# Access Compliance Report

## Public Rights-of-Way

### (Curb Ramps)

Intersection ID: 30468	Main Street: GOLDEN_VIEW_DR	Cross Street: OWLS_PERCH_DR	Location: NW
ADA ID: 37DA9BF7AC02	Ramp Type: PerpDiag	Initial Pass/Fail: Fail	Overall Compliance: No
Severity Score: 21.25			
Codes/Mitigation Info/Possible Solution		Field Measurements/Component Compliance

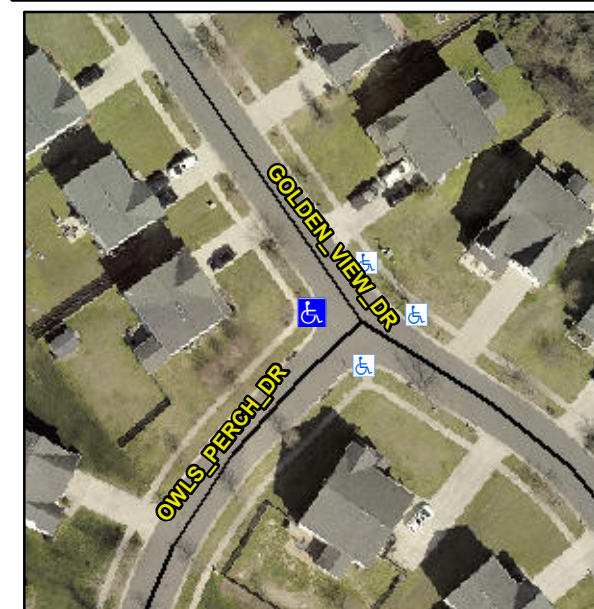
**Not Found, R304.5.1, R304.5.3**

Compliance	Description	Data	Compliance	Description	Data
N/A	Ramp Length (in)	83.0	Yes	Ramp Slope (%)	6.3
No	Ramp Width (in)	46.0	No	Ramp XSlope (%)	5.9
N/A	Flare Type LT	N/A	N/A	Flare Type RT	N/A
N/A	Flare Slope LT (%)	N/A	N/A	Flare Slope RT (%)	N/A
N/A	Flare Traversable LT?	N/A	N/A	Flare Traversable RT?	N/A
N/A	Landing Length (in)	N/A	N/A	DWS Provided?	N/A
N/A	Landing Width (in)	N/A	N/A	DWS Contrast?	N/A
N/A	Landing Slope (%)	N/A	N/A	DWS Length (in)	N/A
N/A	Landing X Slope (%)	N/A	N/A	DWS Full Width?	N/A
N/A	Landing Curb? (Y/N)	N/A	N/A	DWS Offset (in)	N/A
N/A	Shared Landing?	N/A			
N/A	Gutter Ponding?	N/A	N/A	Gutter Slope (%)	N/A
N/A	Gutter Lip Ht (in)	N/A	N/A	Gutter X Slope (%)	N/A
N/A	Painted X Walk1?	No	N/A	Painted X Walk2?	No
	X Walk 1 Direction	To SE		X Walk 2 Direction	To NE
N/A	X Walk 1 Width (in)	N/A	N/A	X Walk 2 Width (in)	N/A
	X Walk 1 Slope (%)	0.5		X Walk 2 Slope (%)	1.1
	X Walk 1 X Slope (%)	2.4		X Walk 2 X Slope (%)	3.4

**Remove & Replace Curb Ramp With Two New Directional Ramps or Equivalent.**
